**CIMARRON
CORPORATION**

***ANNUAL SUBMITTAL OF
27(e) CHANGES FOR (2004)***

DOCKET No. 070-00925
LICENSE NO. SNM-928

Re: Docket No. 070-00925; License No. SNM-928
Annual Submittal of 27(e) Changes

Figure 3-1

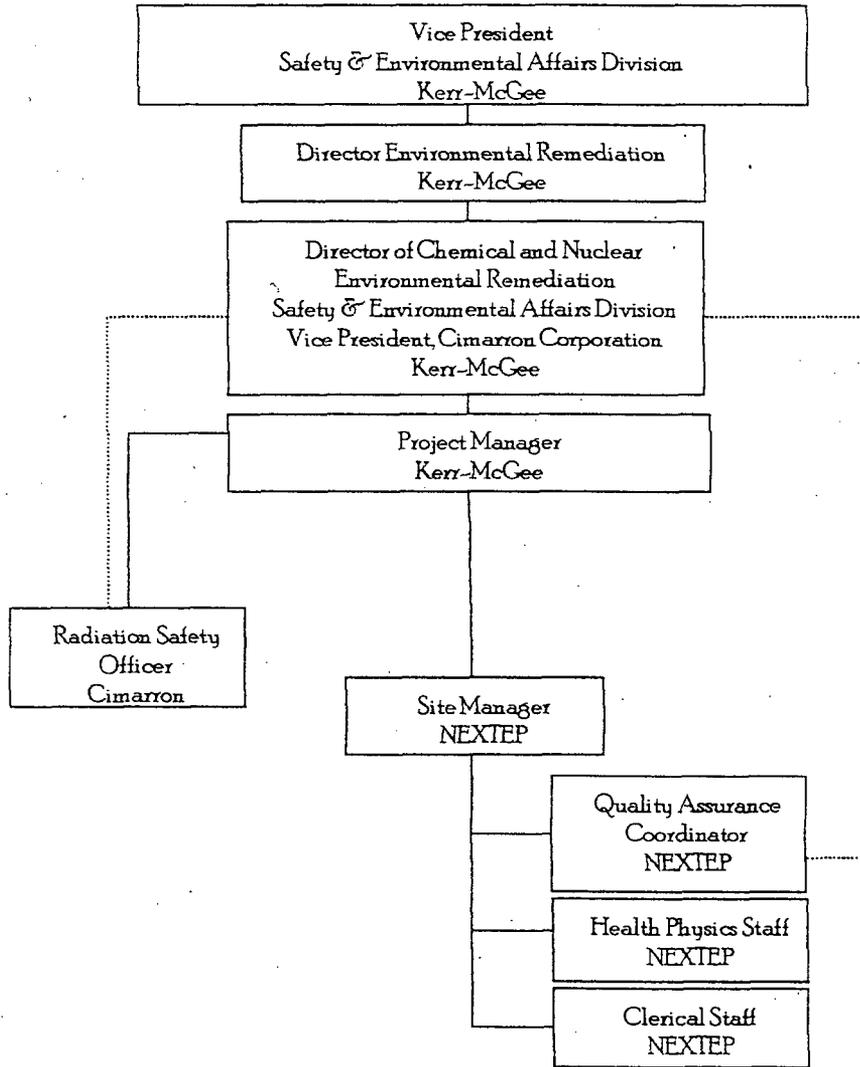
Revision to Organizational Chart – Removal of Program Manager – Sections 2, 3, Table of Contents and Review and Approval Signature Page

Deleted: The Manager of Planning and Regulatory Compliance functions as the Project Manager for the site. The Project Manager is responsible to provide sufficient resources to implement the Radiation Safety Program and to perform site activities. The Project Manager oversees site staff, monitors regulatory requirements, site activities, scheduling and budget status. ¶

The Project manager is responsible to provide sufficient resources to implement the Radiation Safety Program and to perform site activities. The Project Manager oversees site staff, monitors regulatory requirements, site activities, scheduling and budget status.

**FIGURE 15-2
Groundwater Well Locations**

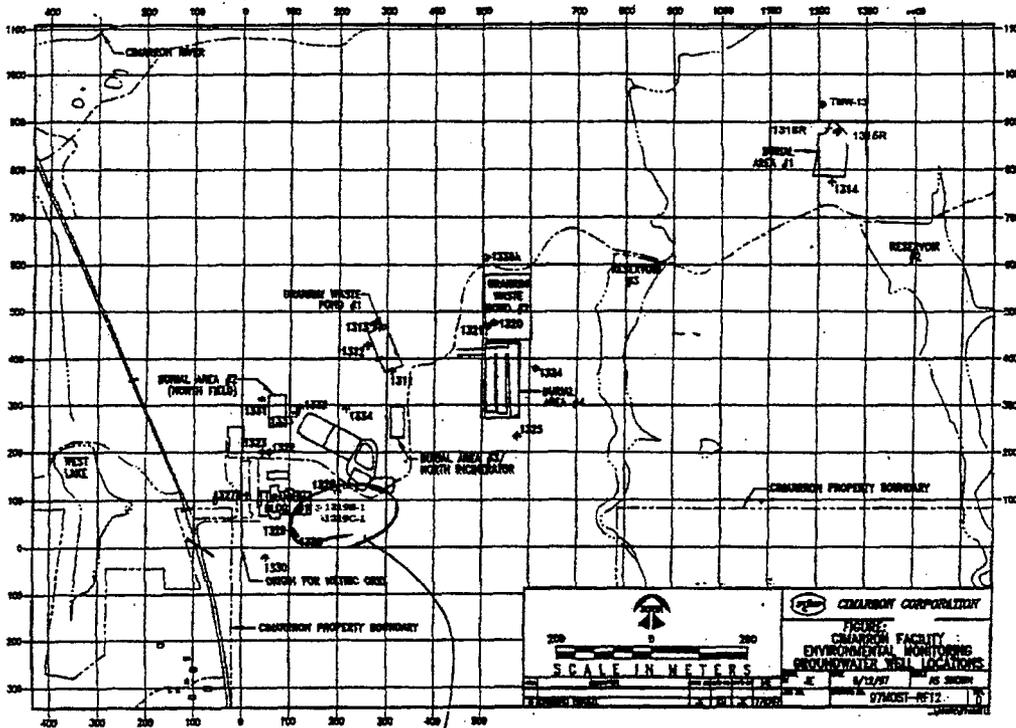
Removal of well 1319 from the Environmental Monitoring Program and replace with new wells 1319B-1 and 1319C-1.

*ADDED
NEW
WELLS*
